26 June 2026

88 Waterloo Road Development

Response to Submissions (Architecture & Urban Design)

Carpark Ramp Section 2

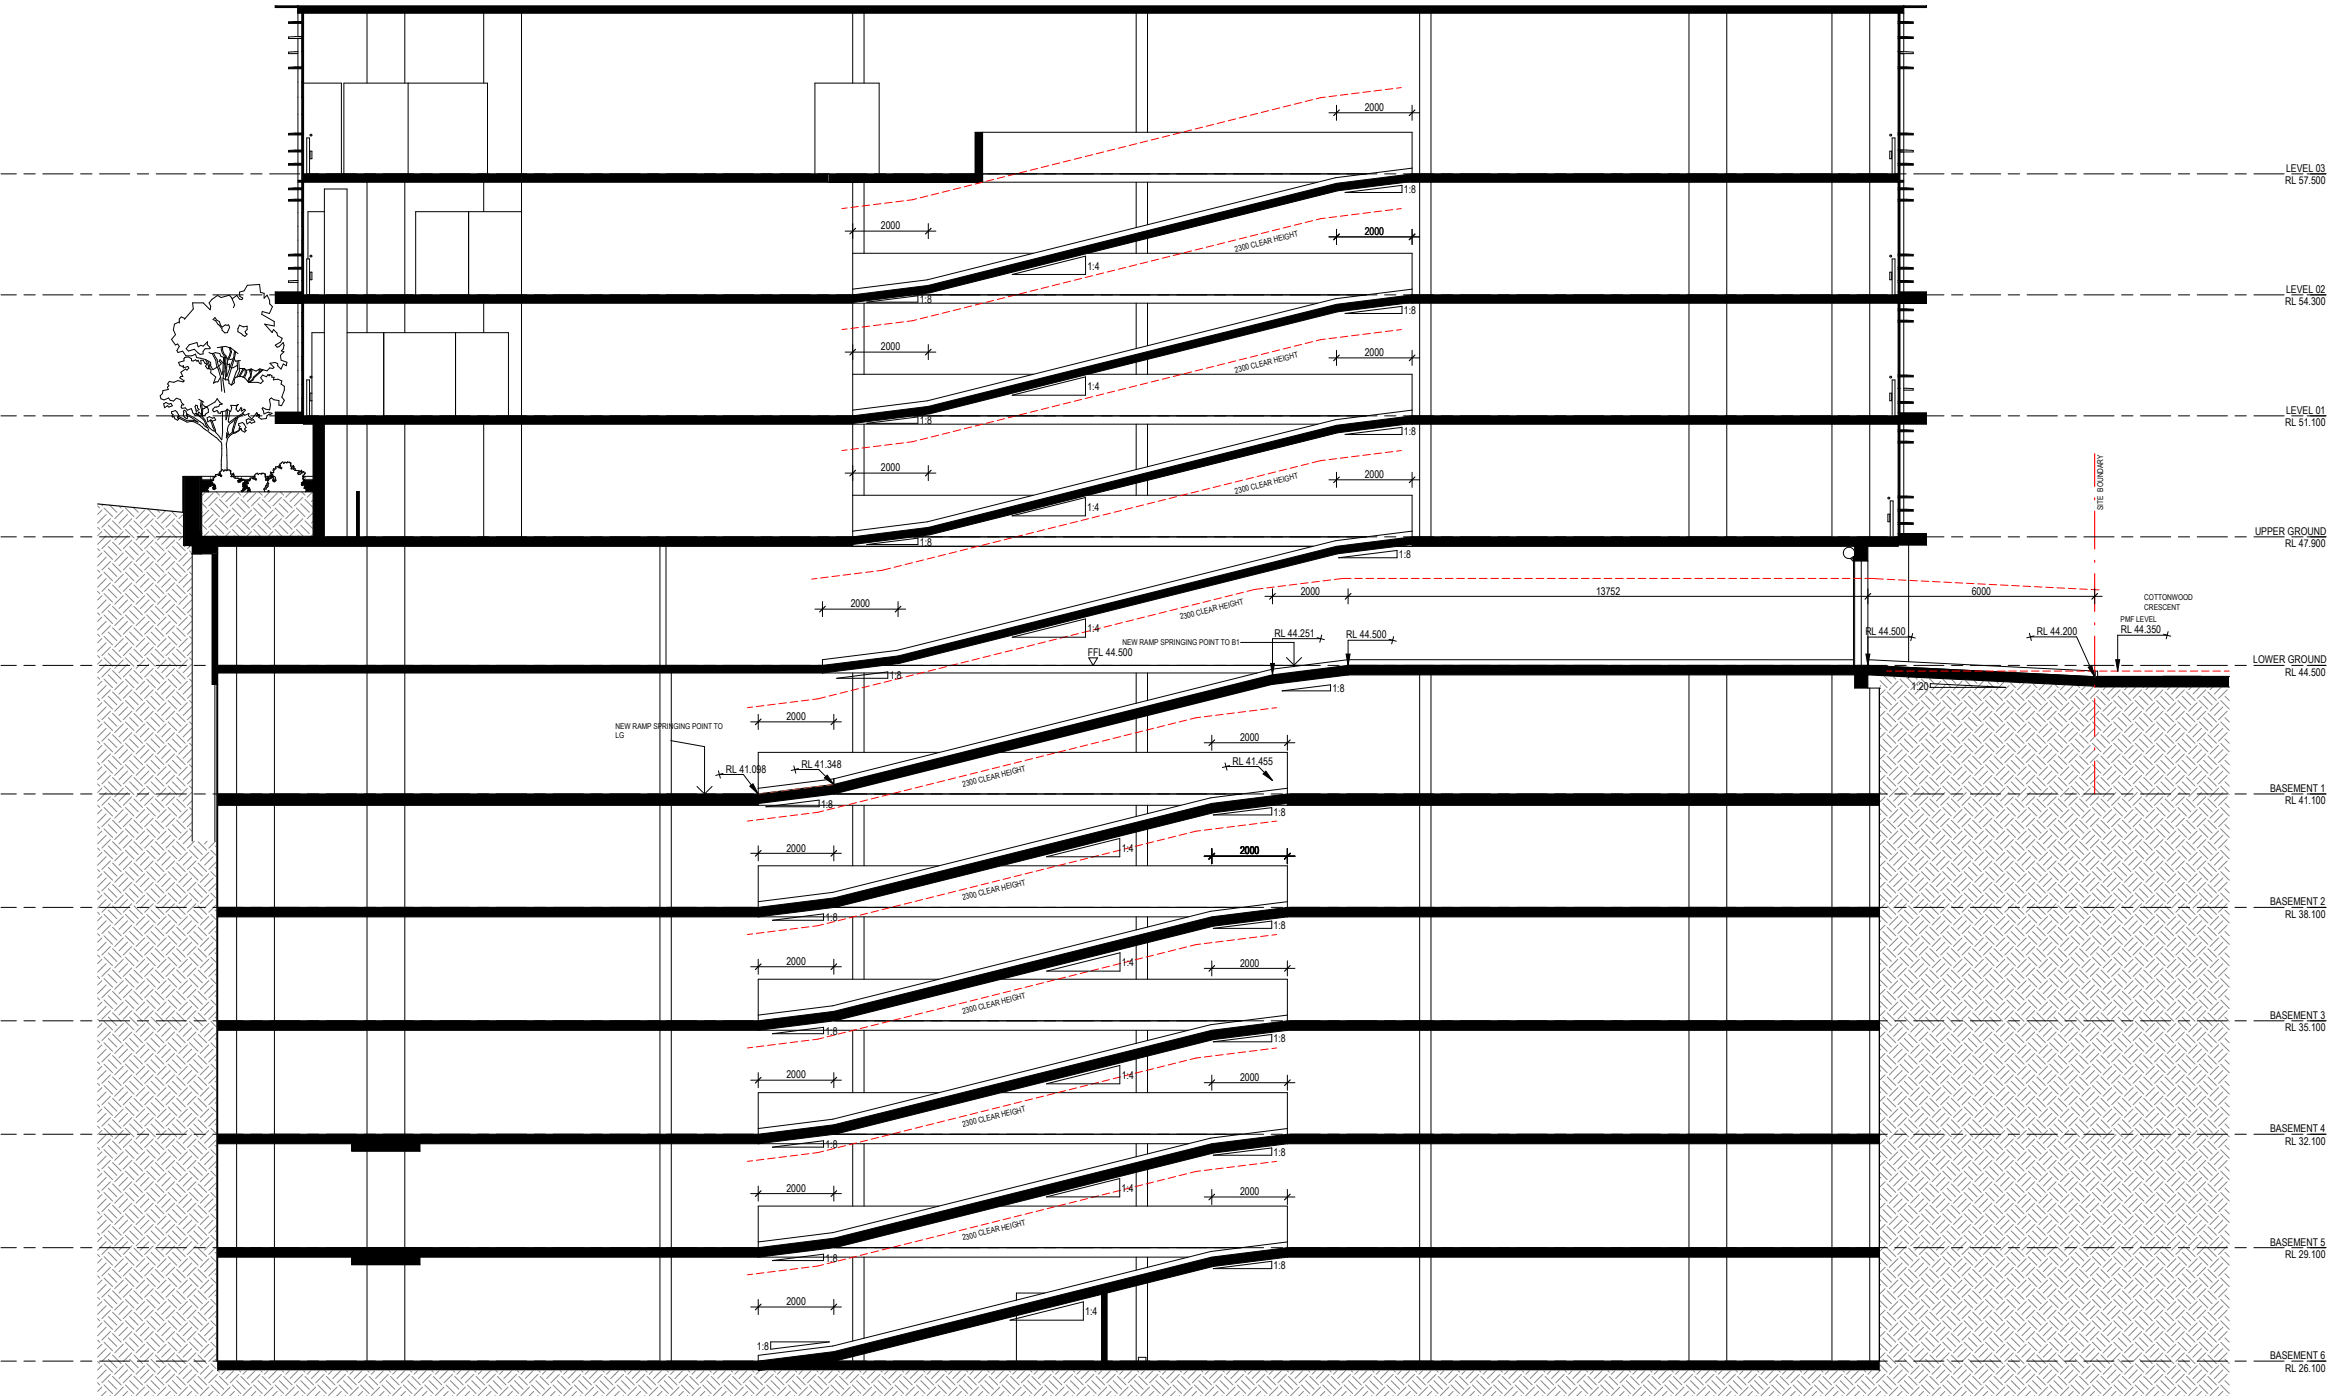
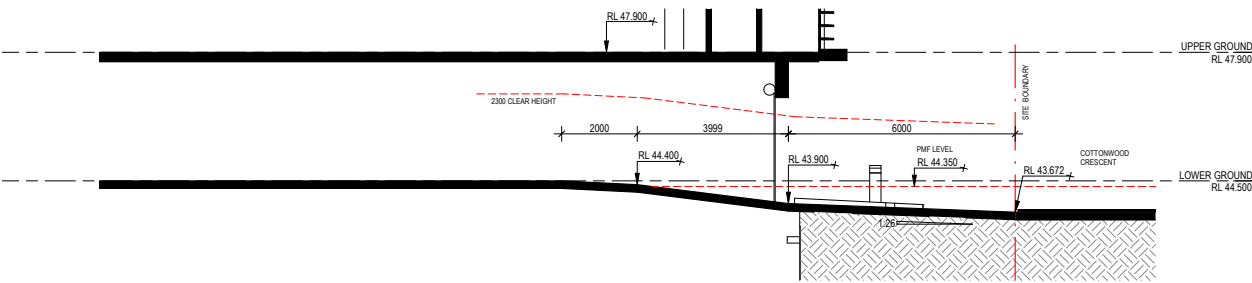
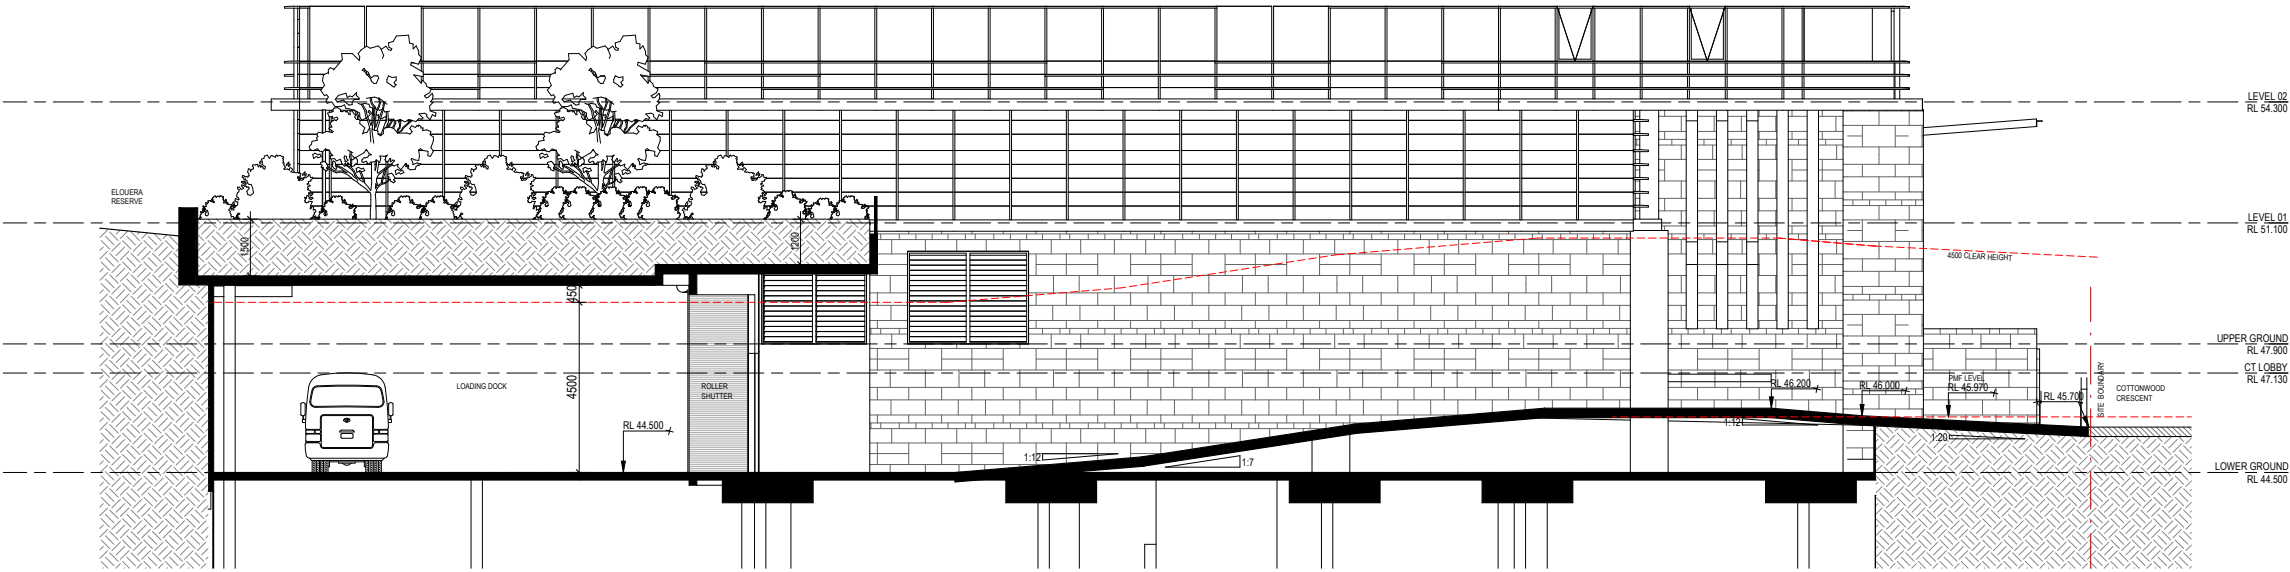
- The architectural plans should include a section taken through both internal ramps so as to confirm that the required grades and height clearances are achieved. It is understood that the driveway may require crest thresholds to be provided to prevent inundation by flood waters and therefore this may complicate a typical stacked ramp

Refer also to previous response that includes a section through basement ramp entrance, which shows a crest threshold above the PMF.
